CITY OF KIRKLAND

NE 85TH ST PED-BIKE CONNECTION
114TH AVE NE TO 6TH ST
JOB NO. 37-24-PW CIP No. STC1070000

ADDENDUM No. 3 TO THE PLANS, SPECIFICATIONS, PROPOSAL AND CONTRACT

Issued This Date: Friday, January 31, 2025
Bid Opening: **Unchanged – February 5, 2025**
Place of Opening: City Hall, Council Chambers

DWG. NO. RP5

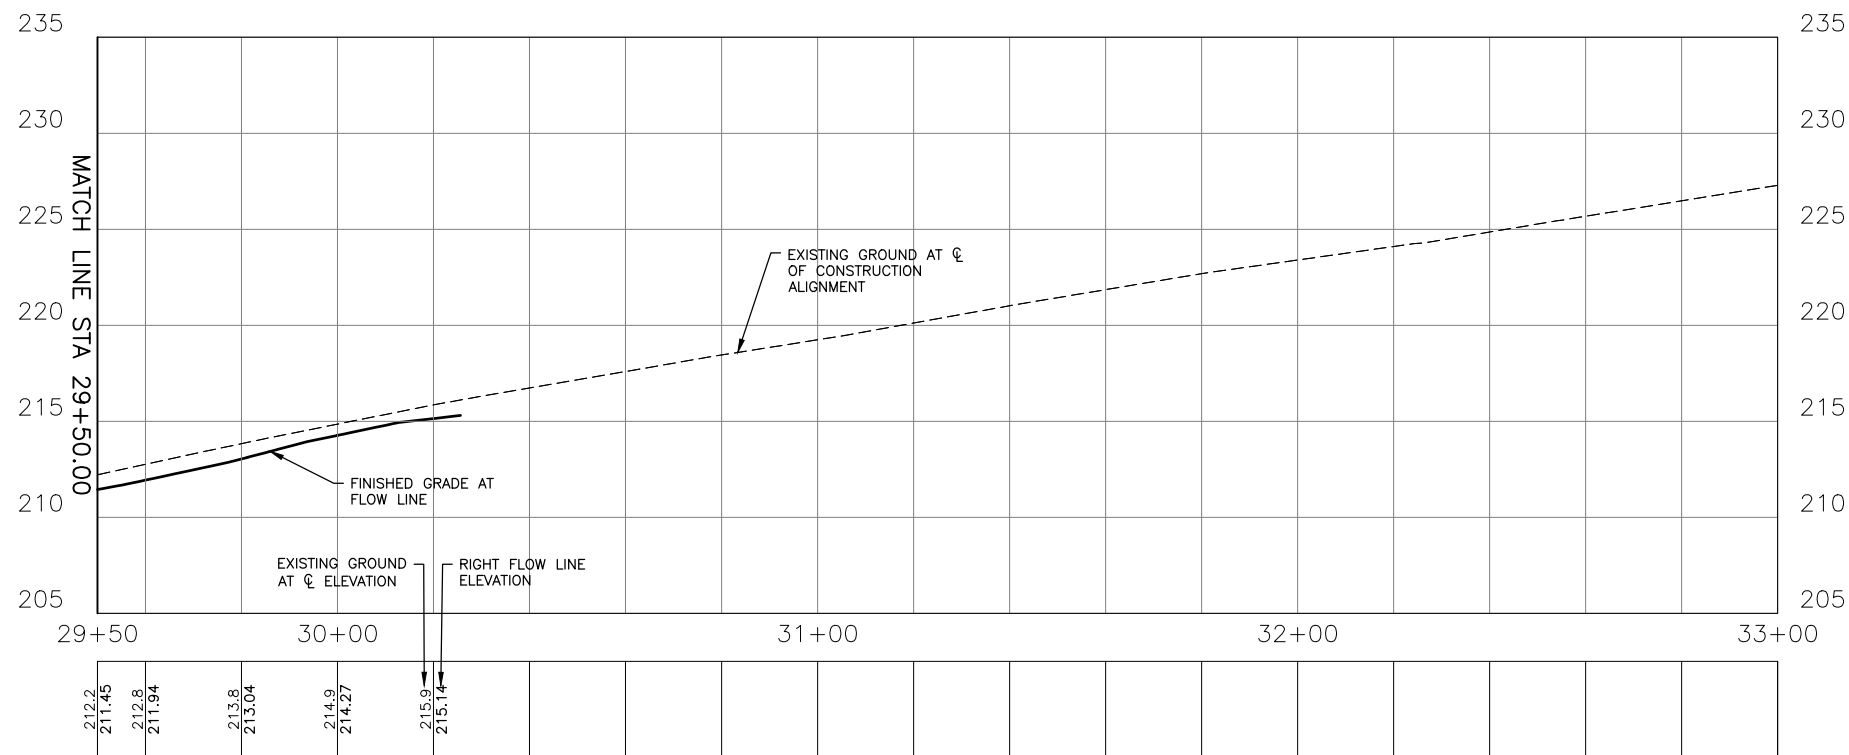
FILE	ENGR.	REVIEW	SCALE	DATE
RP5	##	##	AS SHOWN	JANUARY 2025
1	STAMPED CONC. DEPTH UPDATE	VWW	VWW	1/31/2025
NO.	REVISION	BY	REVIEW	DATE

DWG. NO. DD1

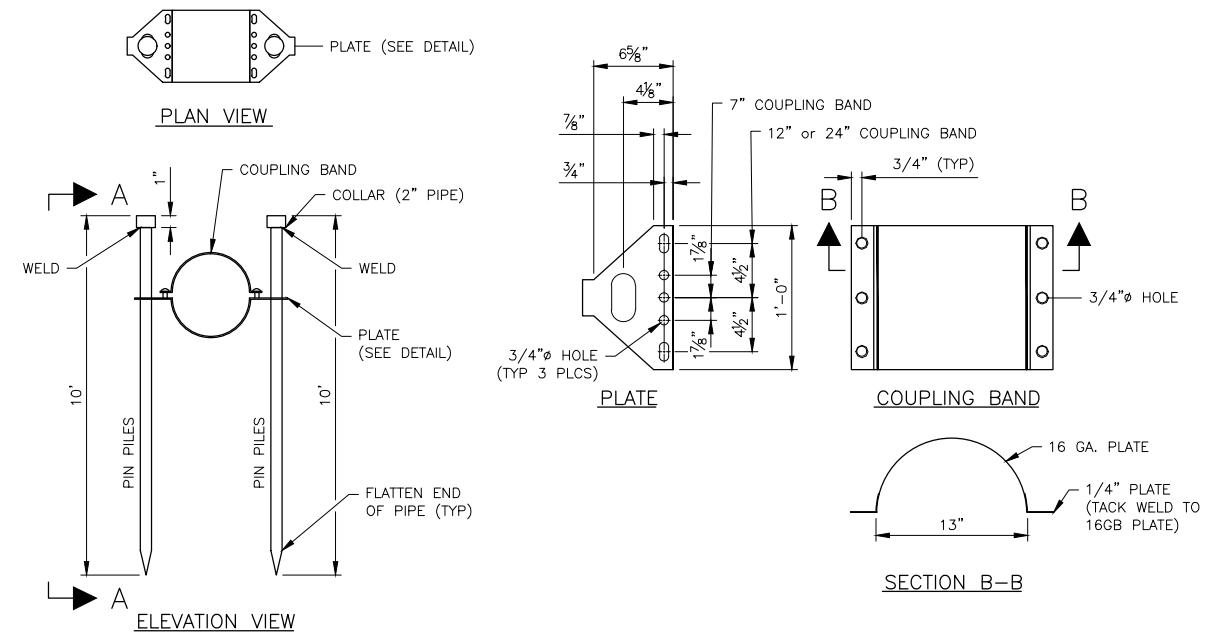
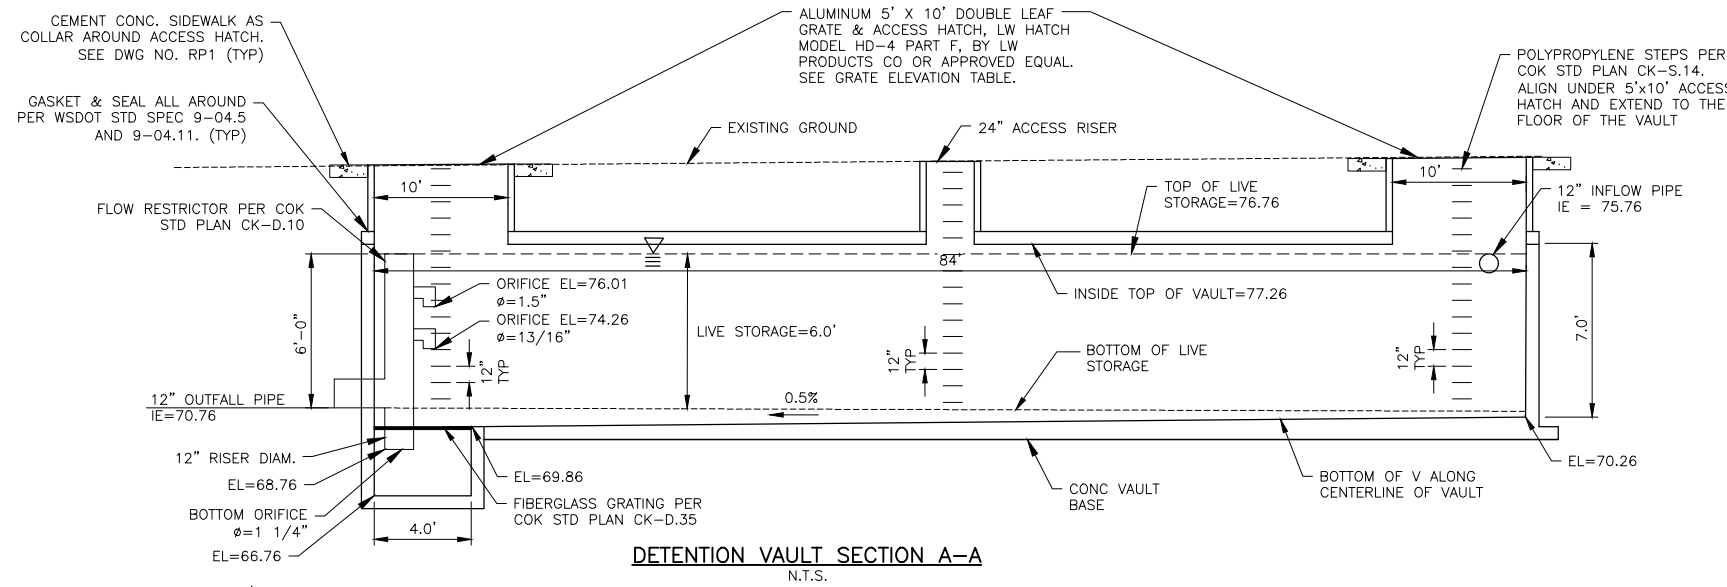
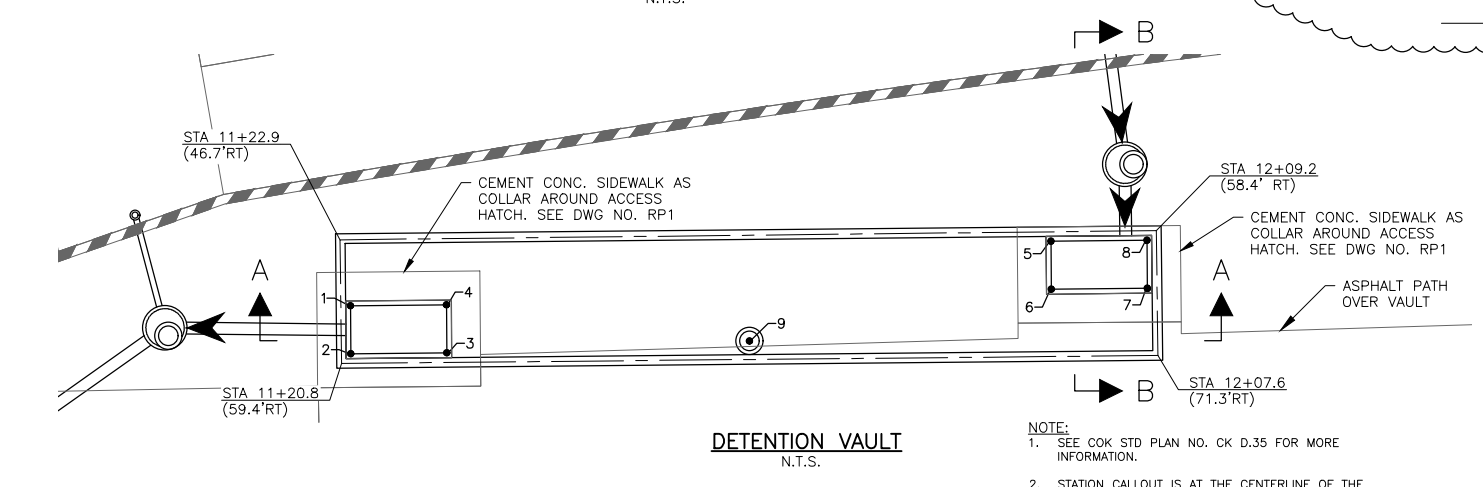
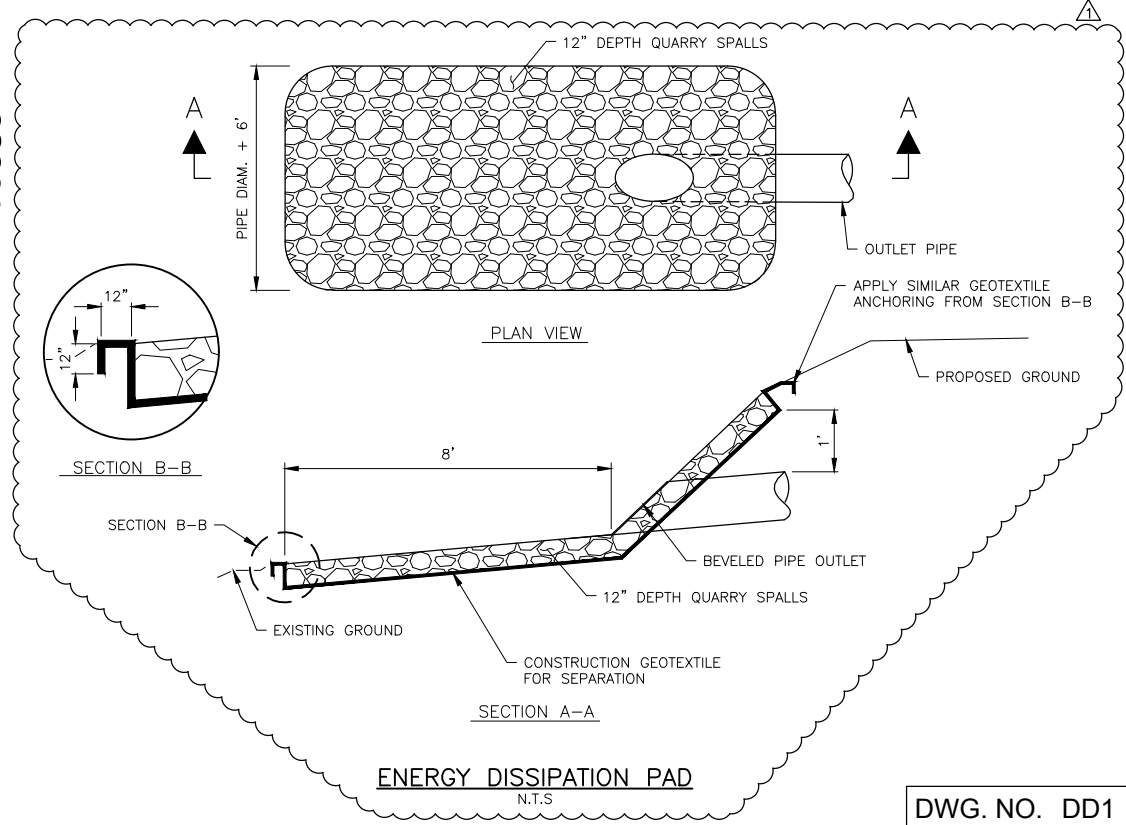
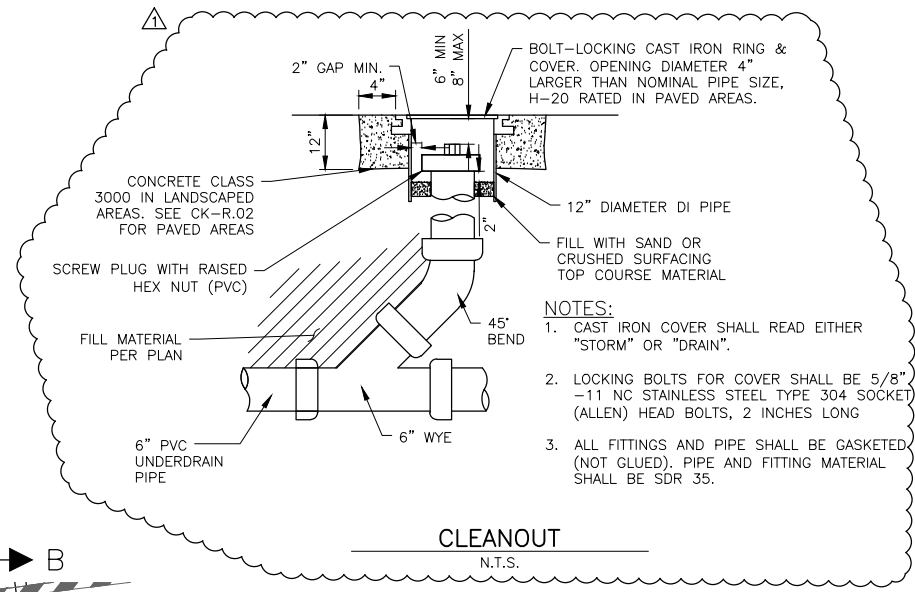
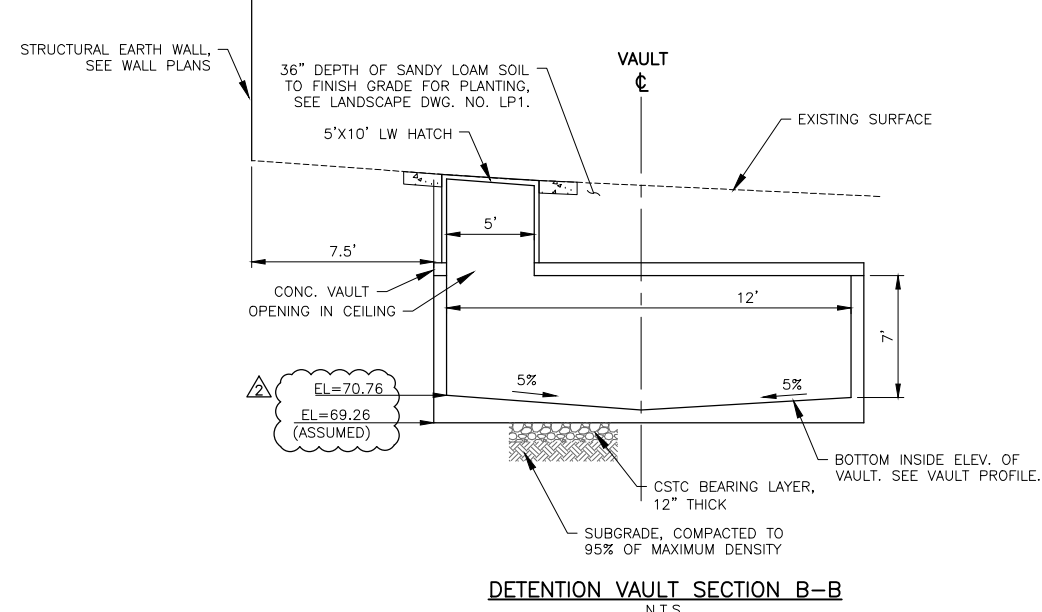
FILE	ENGR.	REVIEW	SCALE	DATE
DD1	##	##	AS SHOWN	JANUARY 2025
ENERGY DISSIPATION PAD DETAIL			TWC	VWW
FLOW SPLITTER DETAIL UPDATE			TWC	VWW
DETENTION VAULT ELEVATION UPDATE				
NO.	REVISION	BY	REVIEW	DATE
